Federal Motor Vehicle Safety Standards; Occupant Crash Protection

ACTION: Correcting amendment.

SUMMARY: This rule corrects an error in the figure for the removable dash label

Figure 12. Removable Label on Dash.

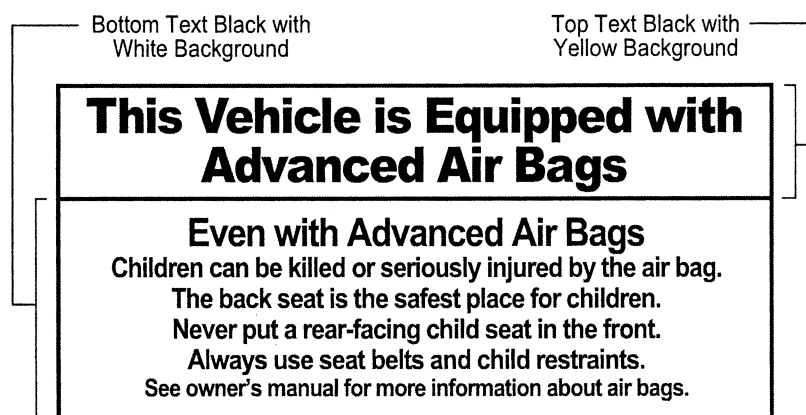
However, the inclusion of the statement in the sun visor label, but not the dash label, created an inconsistency between the labels. Prior to the January 2003 amendment, the advanced air bag sun visor label (FMVSS No. 208, Figure 8) and the current advanced air bag dash label (FMVSS No. 208, Figure 9) were

In response to the January 2003 final rule, Honda commented that, "the Removable Label on Dash (Figure 9) that should correspond to the applicable sun visor label was not amended. To avoid confusing or misleading users, the statement '*never put a rear-facing child seat in the front*' should be added in the removable label." The agency agrees that the warnings on the removable dash label and sun visor label should be consistent.

To maintain consistency and conform the dash label to the sun visor label, Figure 12 is added to FMVSS No. 208, which is identical to Figure 9 except that Figure 12 has an additional bullet point stating: "Never put a rear-facing child seat in the front." Maintaining the uniformity of the dash and sun visor labels ensures that users are not confused as to the importance of placing rear-facing child seats in the vehicle's back seat. To further maintain consistency with the sun visor label, the bullet point will not be required on the temporary dash label if the vehicle has no back seat or the back seat is too small to accommodate a rear-facing child restraint.

The removable dash labels required on vehicles certified on or after December 1, 2003, must conform to Figure 12 of FMVSS No. 208. The labels on vehicles certified before December 1, 2003, must conform to either Figure 9 or 12.

(iv) If the vehicle does not have a back seat or the back seat is too small to accommodate a rear-facing child restraint consistent with S4.5.4.1, the label shown in Figure 12 may be modified by omitting the statement: "Never put a rear-facing child seat in the front."

(iv) If the vehicle does not have a back seat or the back seat is too small to accommodate a rear-facing child restraint consistent with S4.5.4.1, the label shown in Figure 12 may be modified by omitting the statement: "Never put a rear-facing child seat in the front."
